Addendum # 2
Issue Date: July 9, 2014

Newport News Redevelopment & Housing Authority
Division of Purchasing
227 27th Street P.O. Box 797
Newport News, VA 23607
Phone: (757) 928-2623 Fax: (757) 245-2144
www.nnrha.com
Family Investment Center/Childs World Roof Replacement
Bid Due Date and Time: No Change

Invitation for Bids
IFB#145-FIC-06-14
June 17, 2014

Revised Plans

ROOF PLAN

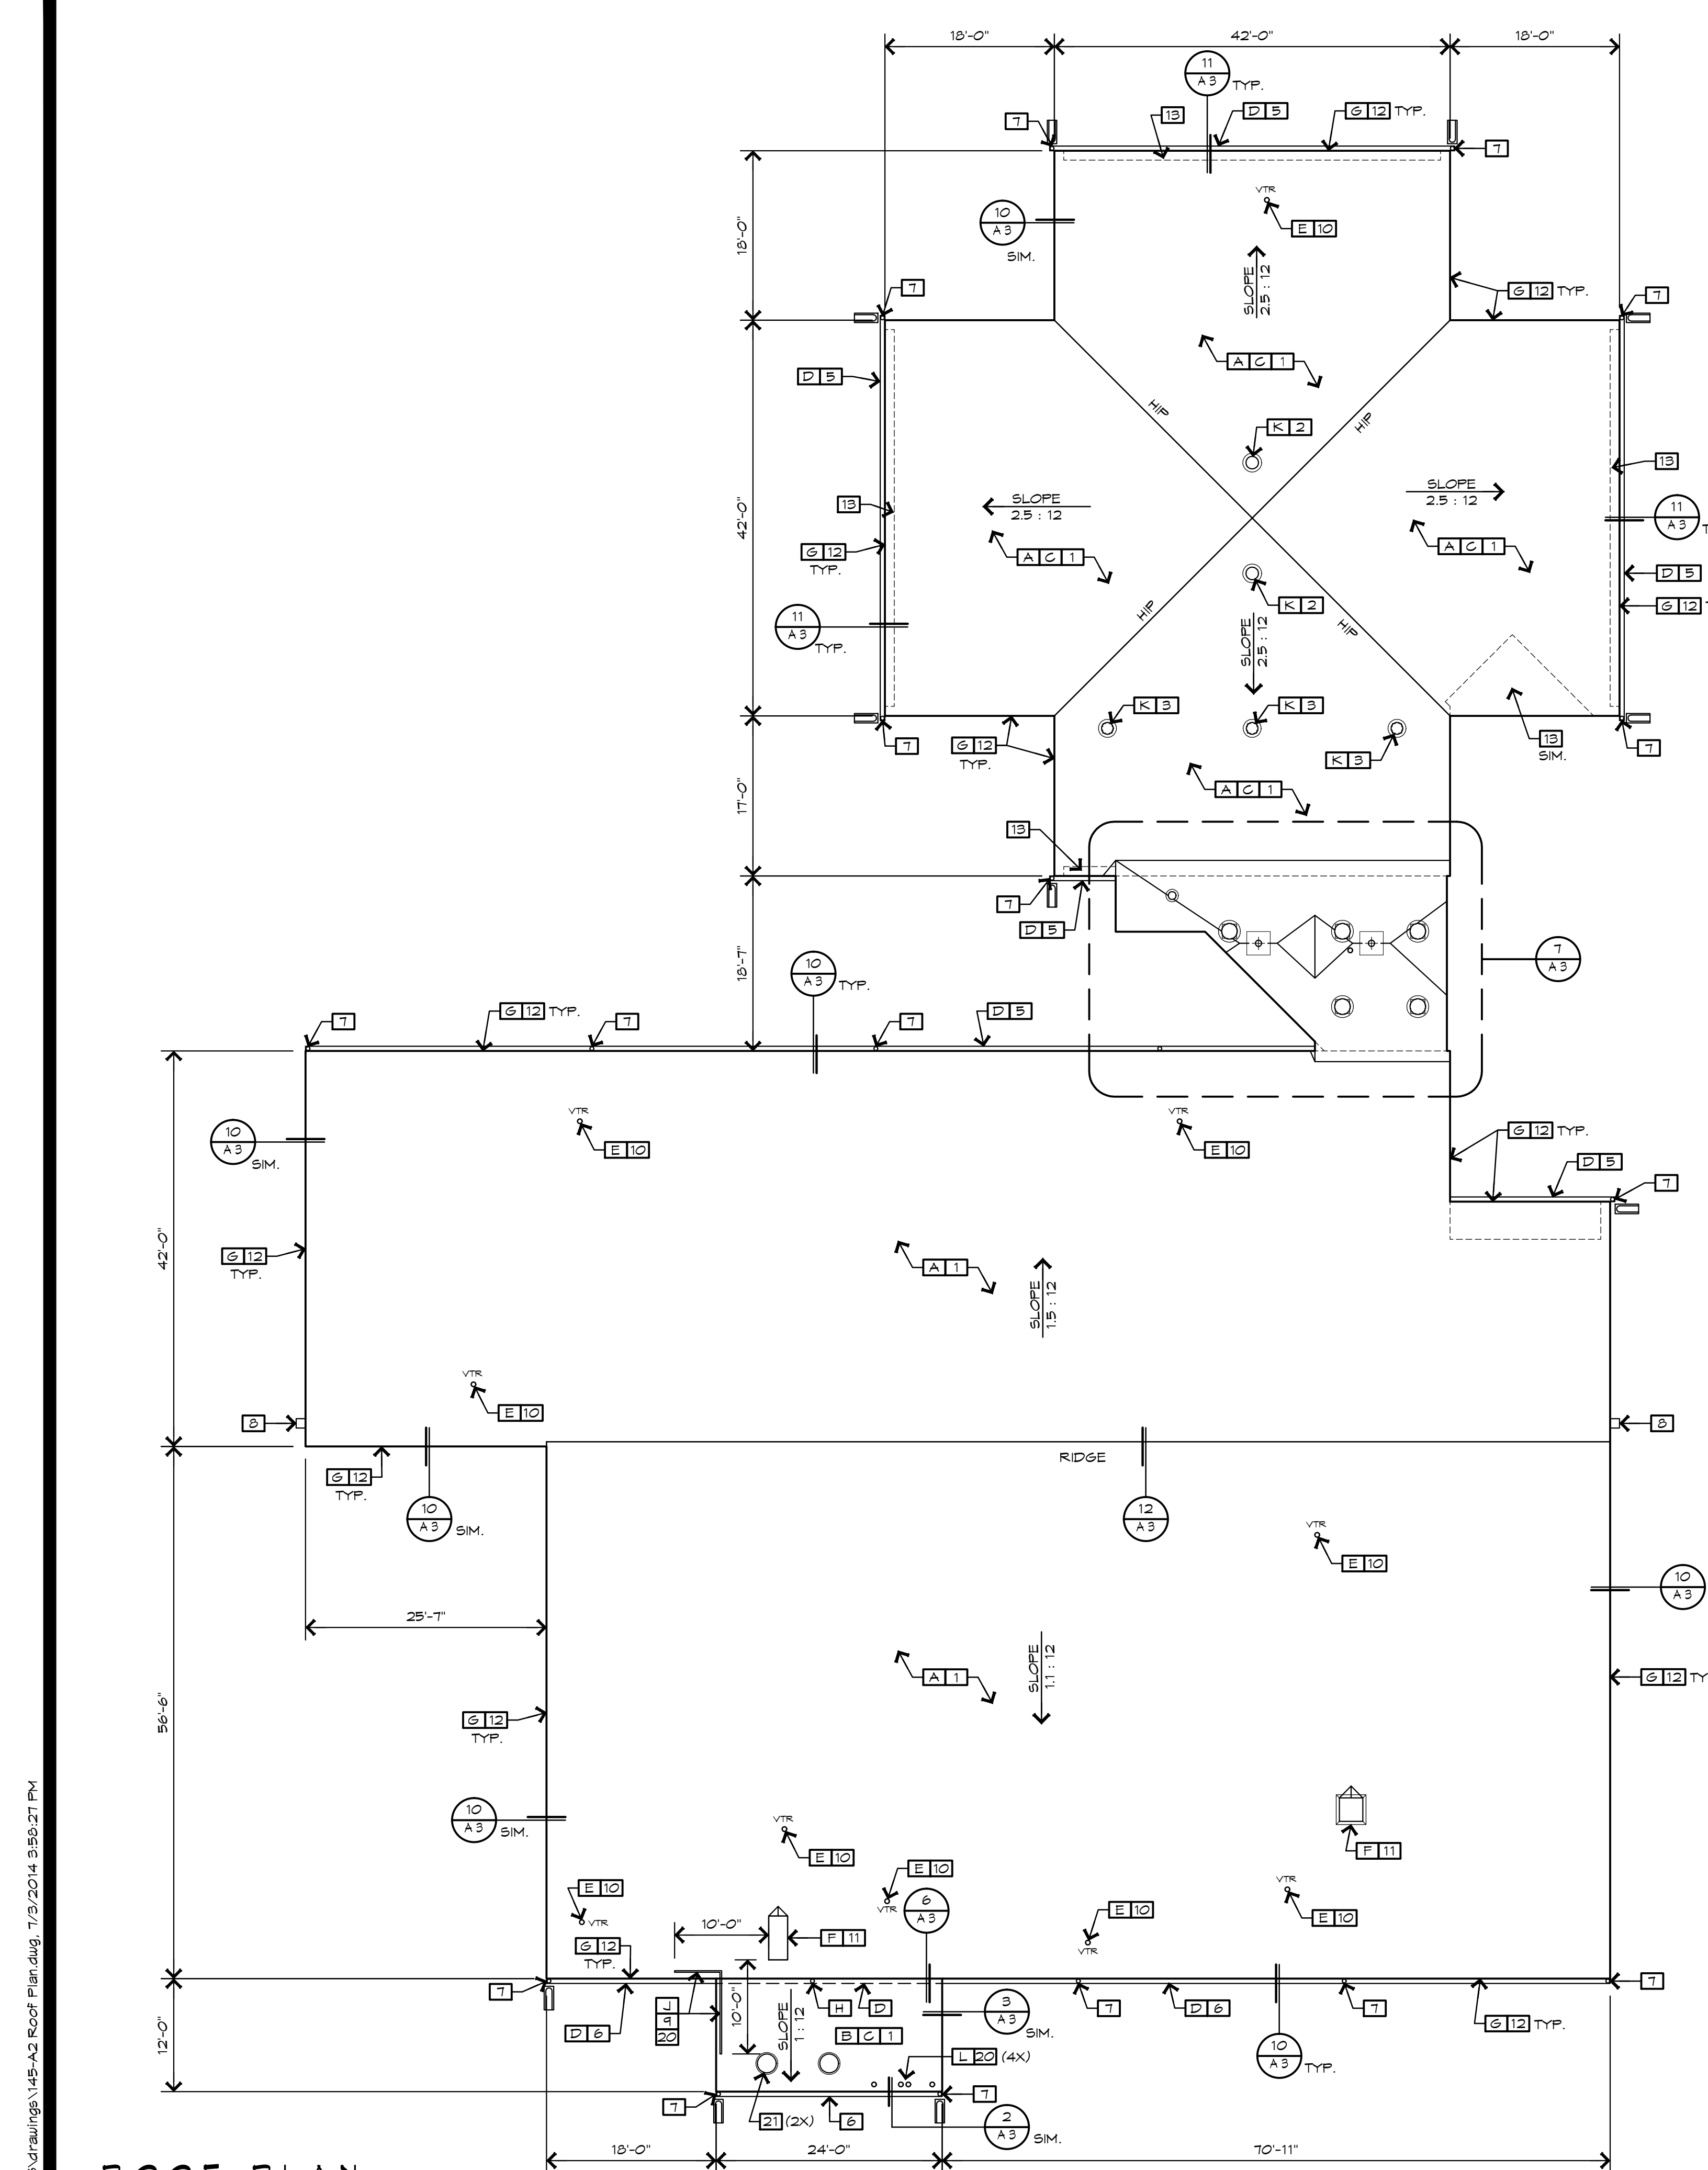
- 1 NEW REINFORCED FVC SINGLE-PLY MEMBRANE ROOFING SYSTEM OVER NEW 1/2" DENS-DECK COVER BOARD, TYP. SEE 1
- 2 (N) 16" DIA. ALUMINUM GRAVITY ROOF VENT, SEE 4

- 3 SAME AS NOTE 2, EXCEPT 15" DIA.
- 4 SAME AS NOTE 2, EXCEPT 20" DIA.
- 5 NEW 0.040" PREFINISHED ALUMINUM GUTTER AT ROOF EDGE, HANG LEVEL, SEE 2
- 6 SAME AS NOTE 5, EXCEPT PITCHED 1/16" PER FOOT.

- 7 NOMINAL 3"x4" RECTANGULAR, SMOOTH DOWNSPOUT AT EXISTING DOWNSPOUT LOCATION. 0.032" PREFINISHED ALUMINUM, COLOR AS SELECTED BY ARCHITECT. PROVIDE ALL REQUIRED ELBOWS, FITTINGS, AND ANCHORS. TERMINATE INTO EXISTING BOOT OR WITH ELBOW ONTO PREGAST CONCRETE SPLASH BLOCK AS INDICATED.

- 8 EXISTING FASCIA-MOUNTED DEVICE TO REMAIN, TYP. REMOVE AND REATTACH TO WALL AS REQUIRED TO ACCOMMODATE NEW WORK.
- 9 (N) WELDED, 1-1/2" DIA. GALV. STEEL PIPE GUARDRAIL 42" HIGH ABOVE ROOF SURFACE WITH INTERMEDIATE RAIL AT 21". PROVIDE POSTS AT MAX 5'-0" OC, EQUALLY SPACED, WITH WELDED BASE PLATES AND ANCHORED THROUGH ROOF DECK INTO SOLID BLOCKING. PROVIDE MOUNTING TO RESIST A LOAD OF 50 PLF IN ANY DIRECTION OR A CONCENTRATED LOAD OF 200 LB AT ANY POINT.

- 10 (N) VENT THROUGH ROOF (VTR) FLASHING FOR FVC MEMBRANE ROOFING SYSTEMS, SEE 5
- 11 FLASH EXISTING EQUIPMENT CURB WITH ROOF MFR'S FLASHING SYSTEM. PROVIDE CRICKET ON UP-SLOPE SIDE OF CURB TO DIRECT WATER AROUND OBSTRUCTION. REINSTALL (E) EXHAUST FAN ON CURB.

- 12 REFACE EXISTING FASCIA, TYP. SEE 10
- 13 REPLACE EXISTING SOFFIT WITH NEW, VENTED ALUMINUM SOFFIT, TYP. SEE 11
- 14 NEW ROOF DRAIN ASSEMBLY TO REPLACE EXISTING IN KIND. INSTALL AND FLASH INTO NEW ROOFING SYSTEM, TYP. SEE 4

- 15 1/2" PER FOOT PERLITE TAPERS MECHANICALLY FASTENED TO EXISTING ROOF DECK. REVERSE EXISTING DECK SLOPE TO ACHIEVE APPROXIMATE SLOPE SHOWN FOR POSITIVE DRAINAGE, TYP.

- 16 1/8" PER FOOT PERLITE TAPERS MECHANICALLY FASTENED TO EXISTING ROOF DECK. ENHANCE EXISTING DECK SLOPE TO ACHIEVE APPROXIMATE SLOPE SHOWN FOR POSITIVE DRAINAGE, TYP.

- 17 EXTEND TAPERS BACK ONTO EXISTING ROOF UNTIL SLOPE MEETS EXISTING ROOF DECK, TYP. PROVIDE SIDE SLOPE TRANSITIONS NO GREATER THAN 3:12.
- 18 EXISTING GAS FLUE VENT TO REMAIN, REPLACE FLASHING COLLAR AND VENT GAP. FLASH INTO NEW ROOFING SYSTEM, TYP.

- 19 SQUARE OFF EXISTING 135-DEGREE CORNER AT FASCIA. PROVIDE NEW 2X FRAMING ANCHORED TO EXISTING WALL CONSTRUCTION. COVER DECK AND FASCIA WITH 1/2" PLYWOOD (MATCH ADJACENT DECK THICKNESS) AND FINISH TO MATCH NEW ROOF, FASCIA, AND SOFFIT TREATMENT. SEE 11

- 20 (N) PIPE FLASHING FOR FVC MEMBRANE ROOFING SYSTEMS, SEE 5
- 21 EXISTING BOILER FLUE VENT TO REMAIN, TYP. FLASH INTO NEW ROOFING SYSTEM.
- 22 BUILD UP EXISTING ROOF EDGE WITH 2X P.T. NAILER(S) AS REQUIRED TO ACCOMMODATE (N) TAPERS, TYP.
